STAFF REPORT
June 6, 2017

AGENDA ITEM: (File No. SPAR-17002)

Consideration of a Site-Plan and Architectural Review application to construct a 245 unit multi-family residential development. The project site consists of two (2) lots located in the Twin Creeks Transit Oriented Development (TOD) Master Plan area within the Medium Mixed Residential (MMR) zone. The 9.51 acre project site fronts North Haskell Street and is identified on the Jackson County Assessor’s Map as 37S 2W 03C Tax Lot 138 and 37S 2W 03DC Tax Lot 3400. **Applicant:** Milo Smith; **Agent:** Scott Sinner.

Exhibit 3. Circulation Plan

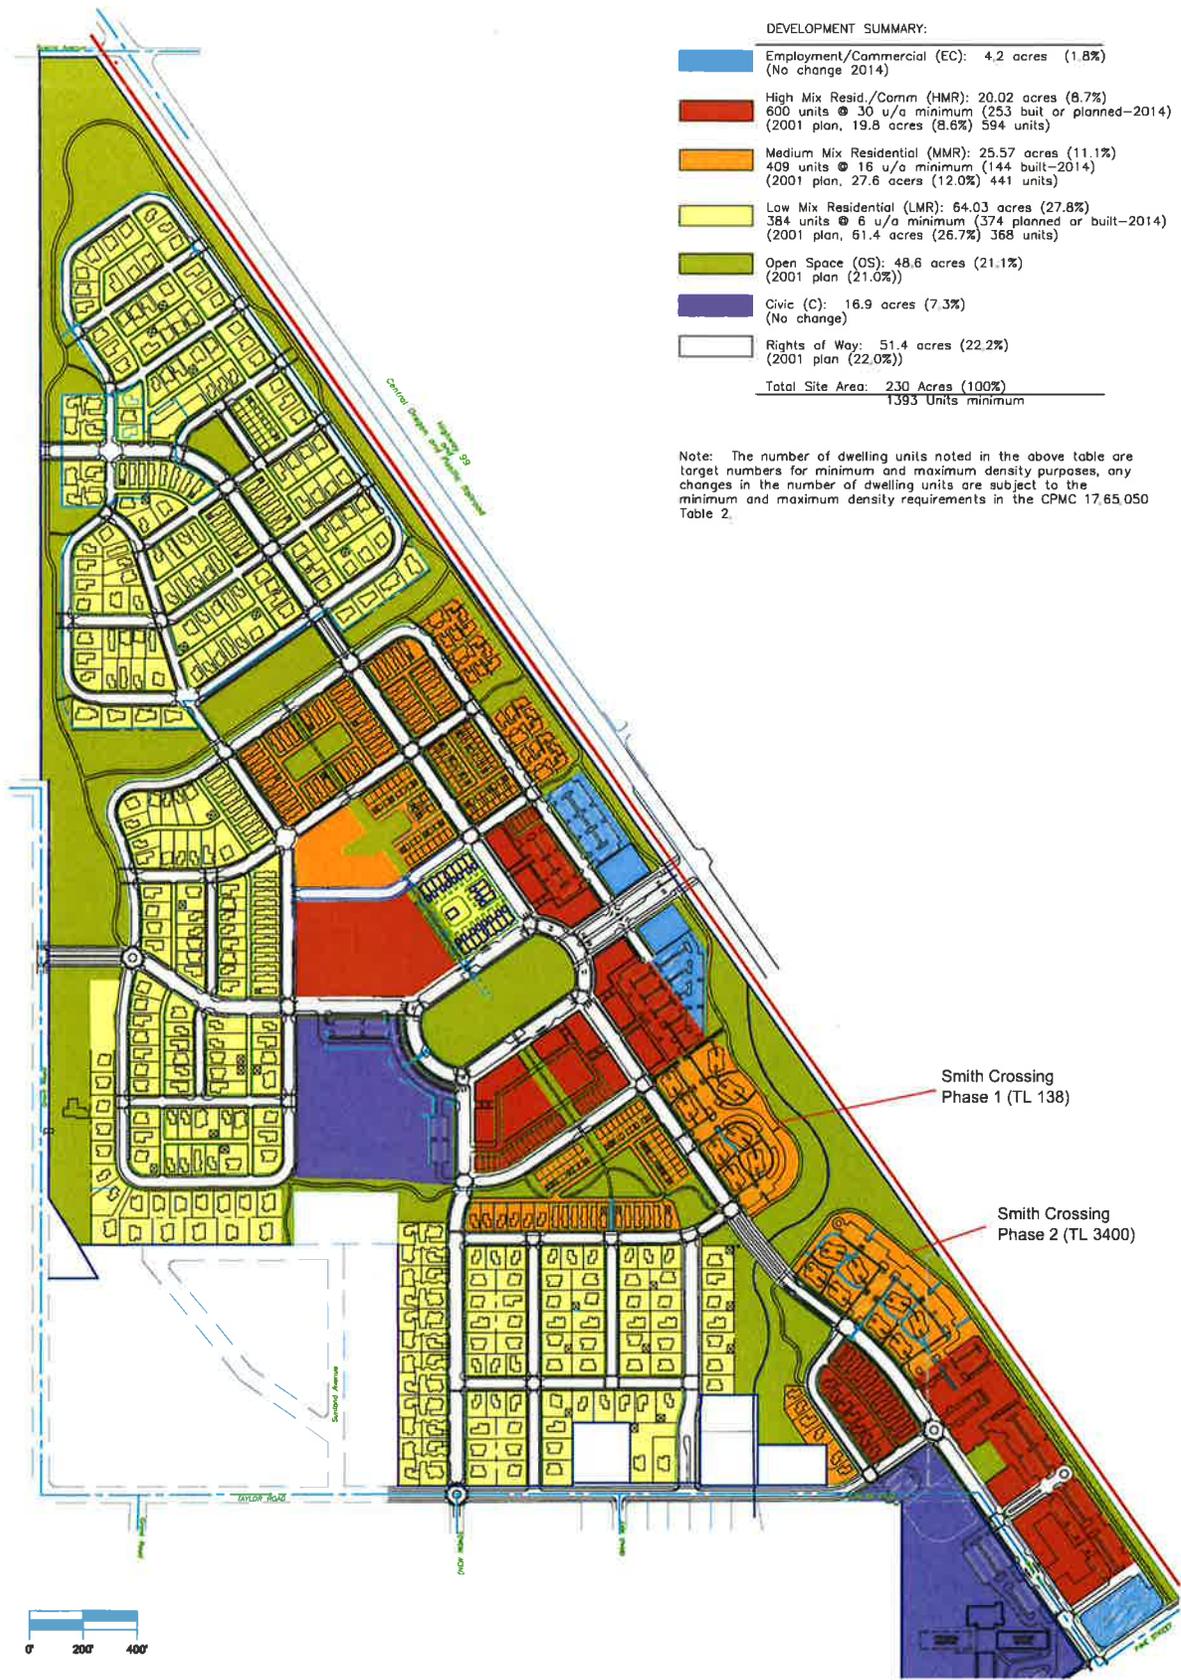
1. **Master Plan.** The Twin Creeks Master Plan governs land use and circulation. A review of the proposed site development in the context of the Master Plan requires clarification of shared access and traffic impacts as follows:
 - a. **Shared Access.** Phase 1 provides a private drive connection with the adjoining property to the northeast (TL 1500), which is illustrated in the Master Plan Exhibit 3, Circulation Detail (Attachment “G”). The Applicant is requesting that the shared connection be for emergency vehicle use only through placement of a fire access gate or similar apparatus. Per the Applicant’s findings, the basis of the request is to avoid potential safety conflicts of off-site commercial traffic generated by a future land use on Tax Lot 1500.

Comment: On January 24, 2017 the Community Development Director approved a senior living and memory care facility on TL 1400 (File No. 16032). At that time the provision for shared open access was shifted to the east to avoid potential conflicts between the residential facility and a future commercial use on TL 1500. The current request reflects similar concerns for resident safety associated with shared open access to accommodate off-site commercial traffic on TL 1500. In consideration of these concerns and written testimony in support of the Applicant’s request provided by the property owner of TL 1500 (Attachment “F”), staff recommends the Planning Commission grant the request to provide shared access for emergency vehicles only.

1. Prior to building permit issuance for any structure in any Phase, the Applicant shall provide a copy of a signed and recorded reciprocal access easement with the adjoining parcel to the North (37S 2W 03CA Tax Lot 1500 and 37S 2W 03CA Tax Lot 1400) ("Lots") as necessary to allow shared access between the Lots for emergency purposes.

SMITH CROSSING AT TWIN CREEKS	TO BE BUILT BY P.M.C.I. INC. 369 DALTON STREET MEDFORD, OR 97501 PHONE: (541) 661-8888	PLOT PLAN PHASE 1 - 100 UNITS
--	--	--	---

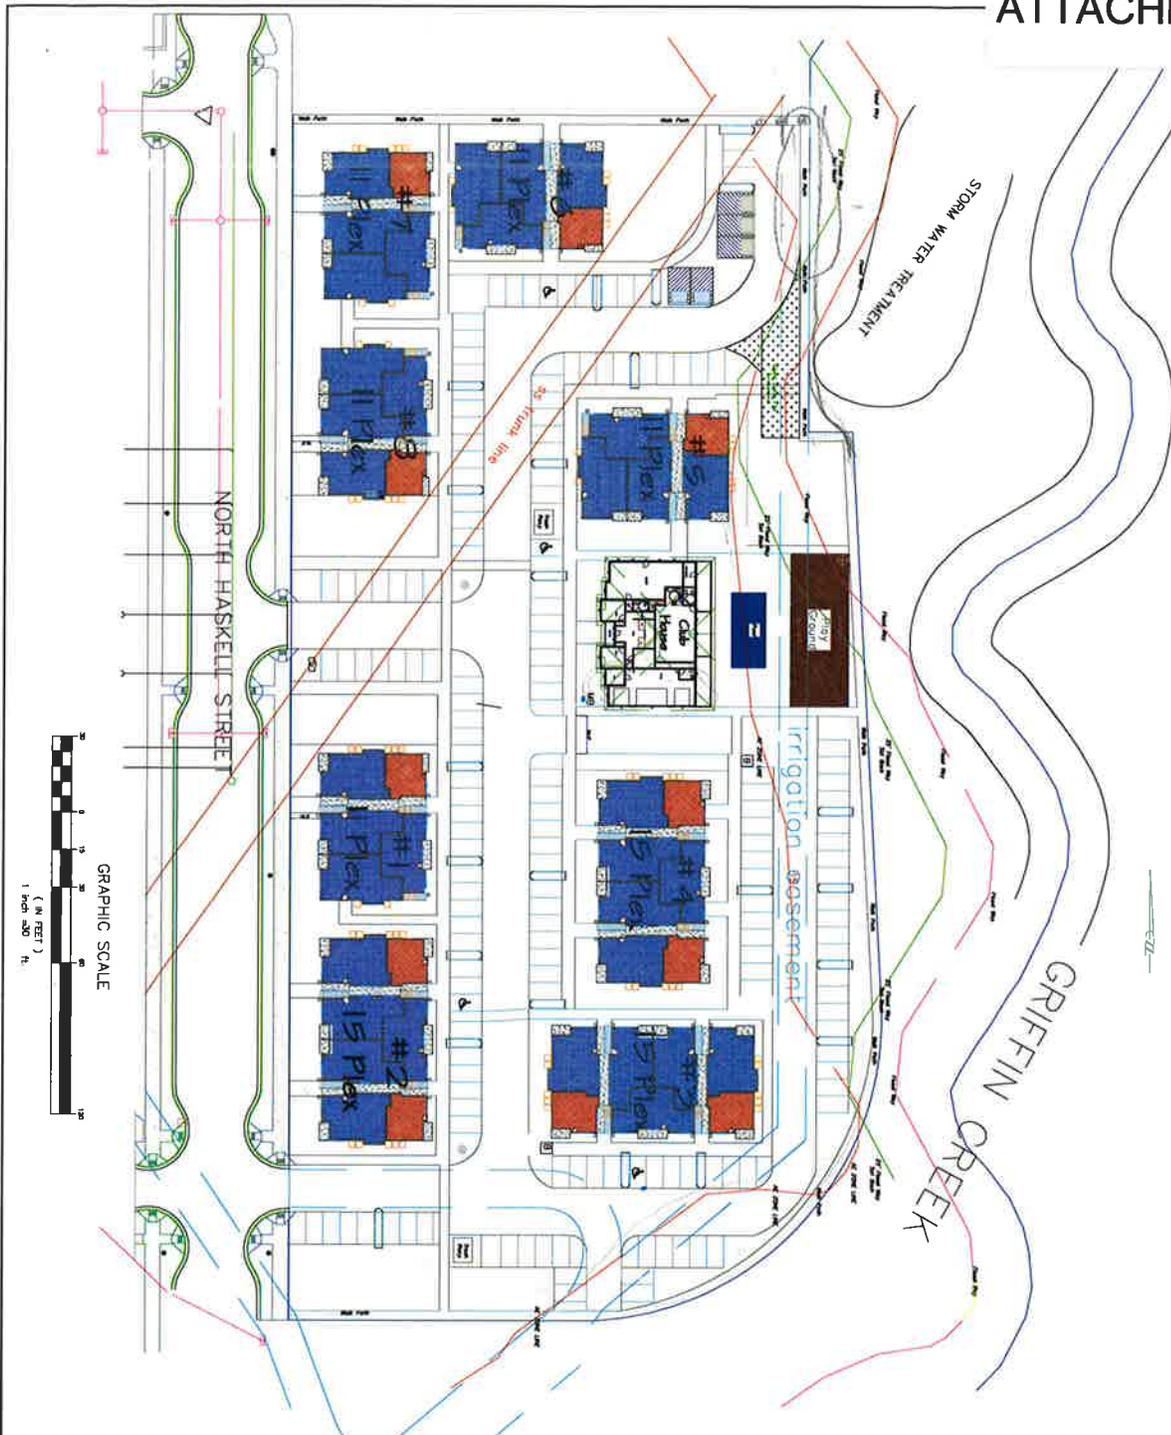
2. **Special Flood Hazard Area (SFHA).** A small portion of Phase 1 is within the SFHA (Attachment “C-1”) Most of the impacted area is planned for parking and landscape improvements but utilities for Building 5 are shown within the SFHA.

Comment: Floodplain development proposals are subject to compliance with CPMC 8.24, Flood Damage Prevention. There are no requirements relative to the proposed landscape and parking improvements; however, Building No. 5 will be subject to the residential construction standards for development in high risk floodplains. Compliance verification is a function of the building permit process. Staff recommends a condition that the Applicant obtain a floodplain development permit for Building No. 5 prior to building permit issuance unless it can be demonstrated through a Letter of Map Amendment (LOMA) that the building site is located above the 100-year flood elevation (Condition No. 3).

3. Prior to building permit issuance for Building No. 5 in Phase 1, the Applicant shall either 1) provide a Letter of Map Amendment (LOMA) from the Federal Emergency Management Agency (FEMA) demonstrating that the site for Building No. 5 is outside Flood Zone AE; or, 2) obtain a floodplain development permit for Building No. 5 in Phase 1 as necessary to comply with CPMC 8.24, Flood Damage Prevention requirements for residential construction.

LANDSCAPE PLAN
Scale 1" = 30'

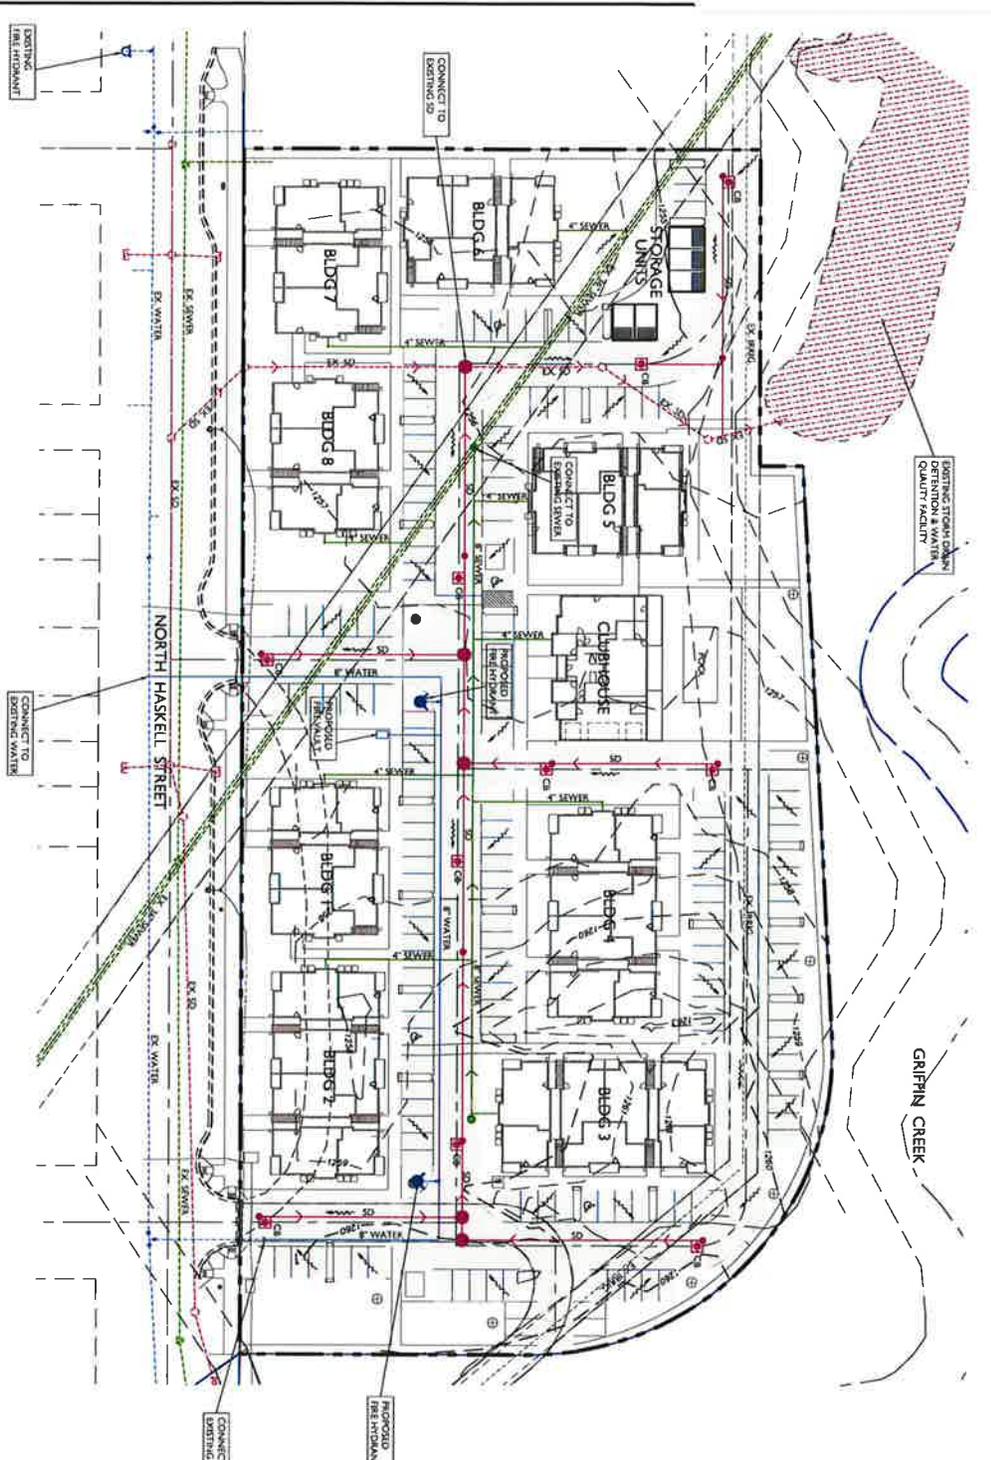
5. **Landscaping.** The Applicant’s Landscape Plan (Attachments “C-12” and “C-13”) does not provide adequate tree placement at the north entrance to Phase 1 as required in CPMC 17.67.050(K)(2)(a). This section of the code requires tree placement at 30-ft on center. Phases 1 and 2 do not provide adequate screening at the parking lot driveway entrances from North Haskell Street. CPMC 17.67.050(K)(2)(b) requires screening evergreen hedges or decorative fences walls or transparent screens.

Comment: There is sufficient area on the site to accommodate the required landscaping and screening per CPMC 17.67.050(K)(2)(a-b). Staff recommends that the Planning Commission impose Condition No. 5 to require submittal of a revised landscape plan at the time of building permit issuance.

5. At the time of building permit issuance, the Applicant shall submit a revised landscape plan demonstrating compliance with the tree planting and parking lot screening requirements in CPMC 17.67.050(K)(2)(a-b).

Exhibit 3, Circulation Plan Detail

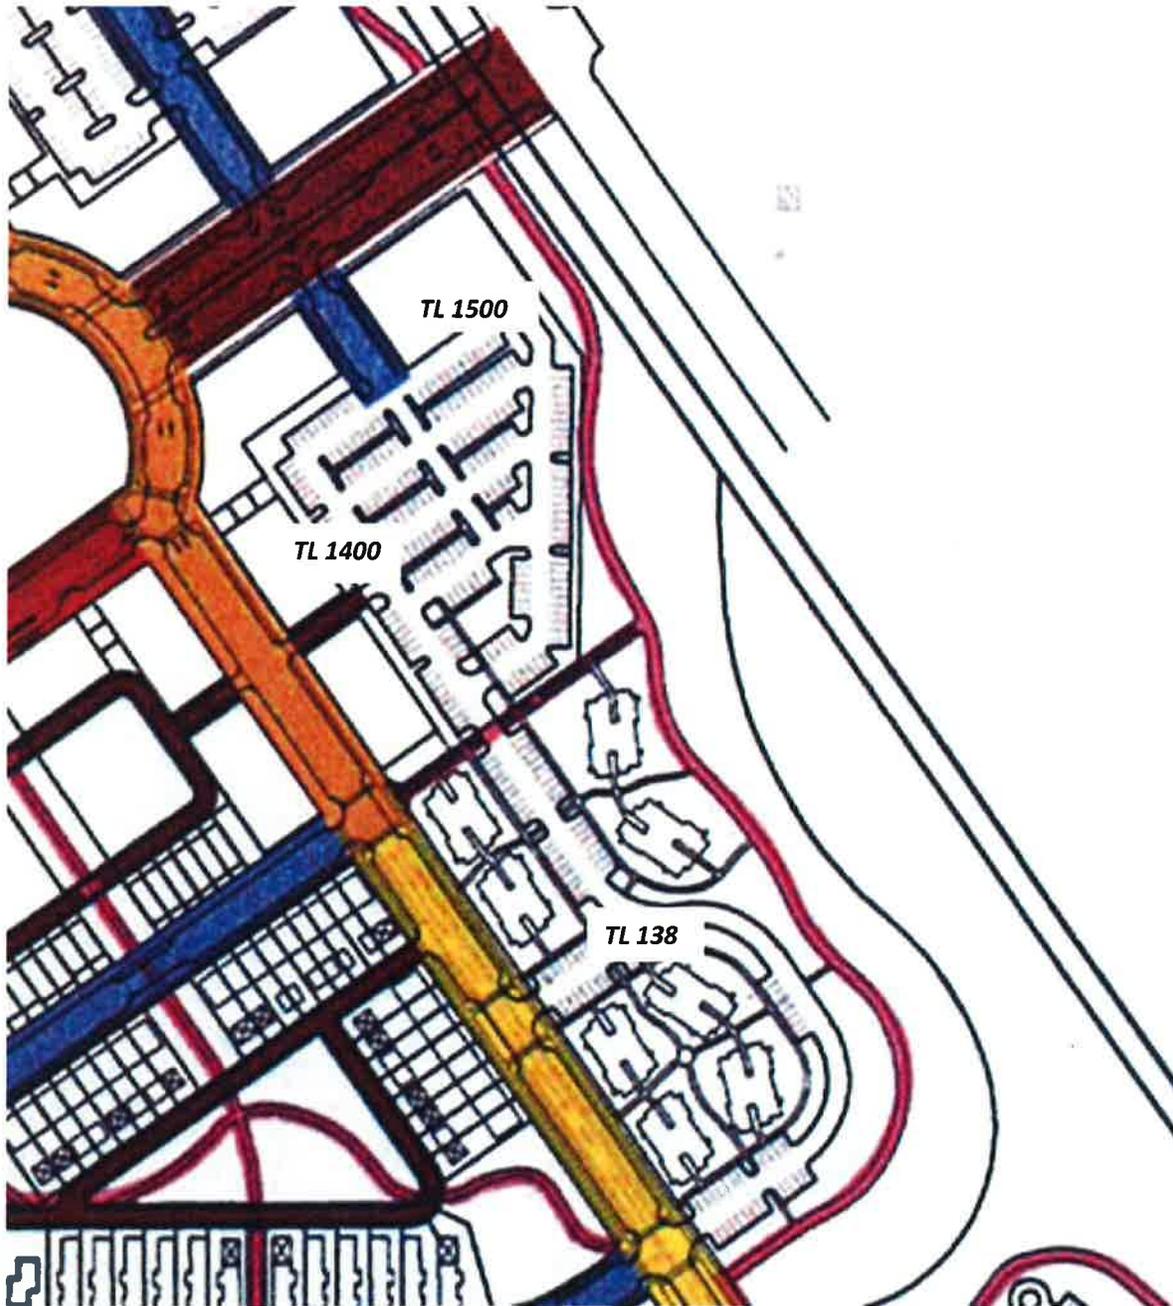
We would like shared access to be limited to use by emergency vehicles between these lots, which will be controlled by a fire access gate or other similar device. The basis of this request is that the Master Plan does not articulate a clear requirement for private shared access other than to illustrate a conceptual connection in Exhibit 3. If required to allow unlimited shared access, there are concerns that commercial traffic generated by a future land use on Tax Lot 1500 would be incompatible with and cause a safety hazard to future residents of the medium residential multifamily development on Tax Lot 138. By limiting access to emergency vehicles only, concerns about resident safety will be addressed.
